Project	IEEE 802.16 Broadband Wireless Access Working Group < http://ieee802.org/16 >	
Title	DL and UL loading parameters information	
Date Submitted	2007-03-13	
Source(s)	Peretz Feder – Alcatel-Lucent Phillip Barber - Huawei Honghai Zhang – Alcatel-Lucent	pfeder@alcatel-lucent.com pbarber@broadbandmobiletech.com hozhang@alcatel-lucent.com
Re:	IEEE 802.16 Session #48	
Abstract	This contribution proposes the updates of IEEE 802.16g D8 document in order to obtain loading information from the Base Station	
Purpose	Update 802.16g draft obtain uplink and downlink loading information	
Notice	This document has been prepared to assist IEEE 802.16. It is offered as a basis for discussion and is not binding on the contributing individual(s) or organization(s). The material in this document is subject to change in form and content after further study. The contributor(s) reserve(s) the right to add, amend or withdraw material contained herein.

DL and UL loading parameters information

Peretz Feder -Alcatel-Lucent
Honghai Zhang – Alcatel-Lucent
Phillip Barber - Huawei

Figure 57 – Maintaining downlink synchronization

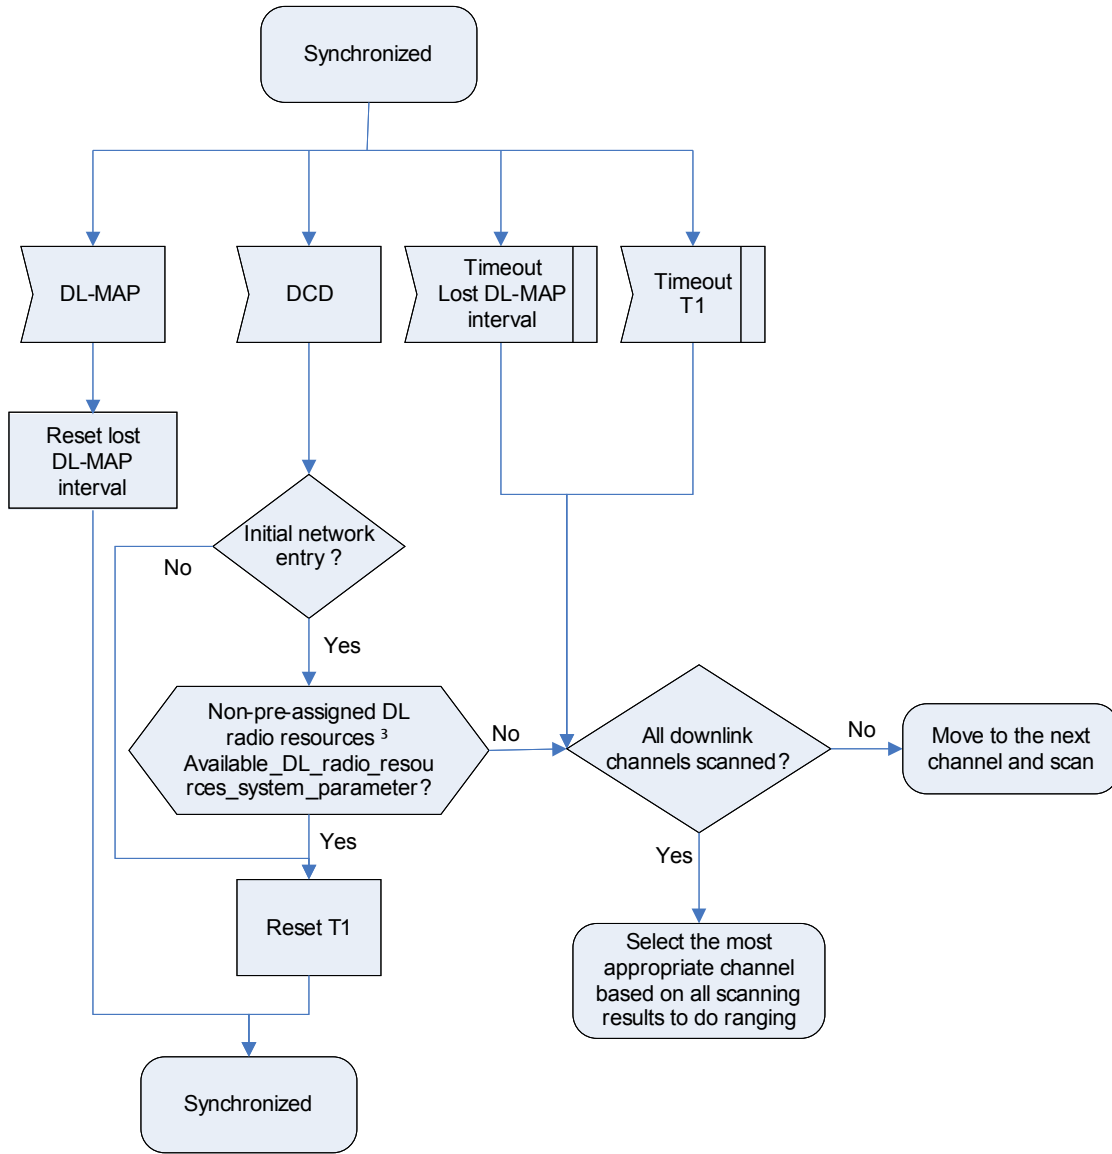
(Note to Editor: Need to modify Figure 57 – see below)

Figure 58 – Obtaining uplink parameters

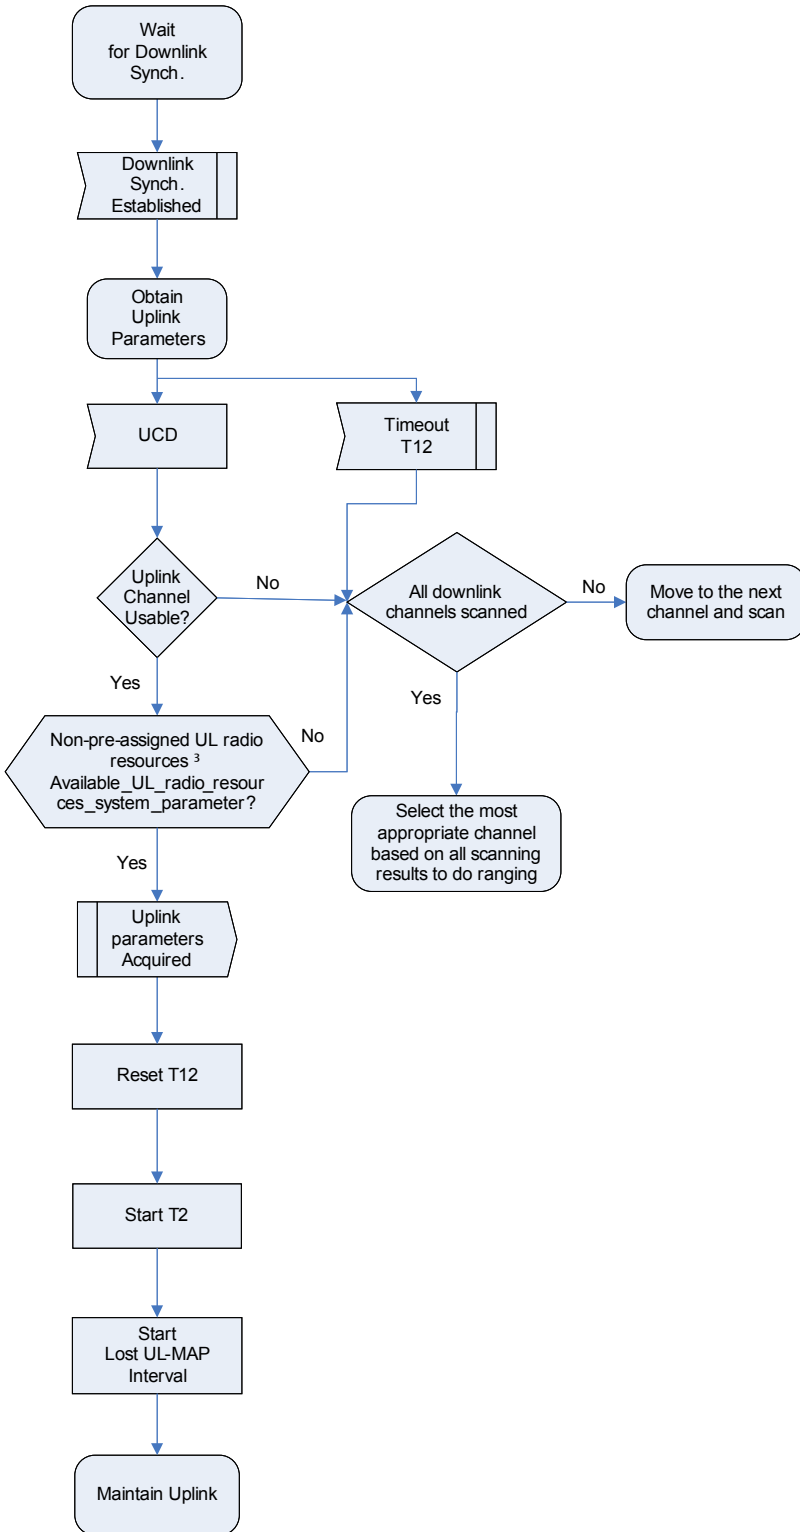
If no uplink can be found after a suitable timeout period, **or if the Non-pre-assigned UL radio resources in the UCD message are lower than the available_UL_radio_resources_system_parameter**, then the SS shall continue scanning to find another downlink channel. The process of obtaining uplink parameters is illustrated in Figure 58. (Editor: need to change Figure 58 – see below)

Figure 59 – Maintain uplink parameters

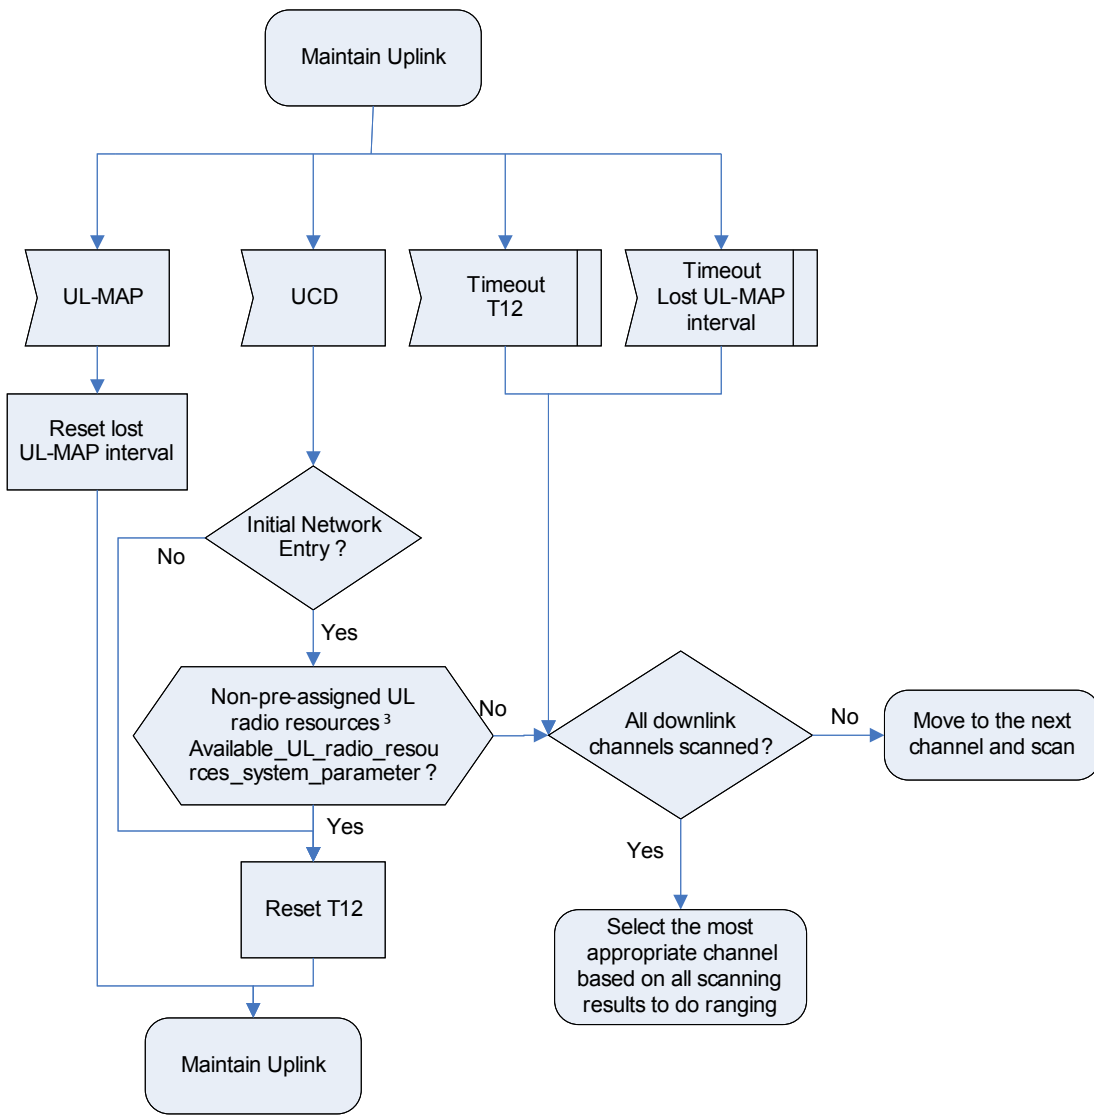
The SS MAC is considered to have valid uplink parameters as long as it continues to successfully receive the UL-MAP and UCD messages. If at least one of the messages is not received within the time intervals specified in Table 342 or the Non-pre-assigned UL radio resources are lower than the `available_UL_radio_resources_system_parameter`, the SS shall not use the uplink. This is illustrated in Figure 59.

(Editor: need to change Figure 59 – see below)
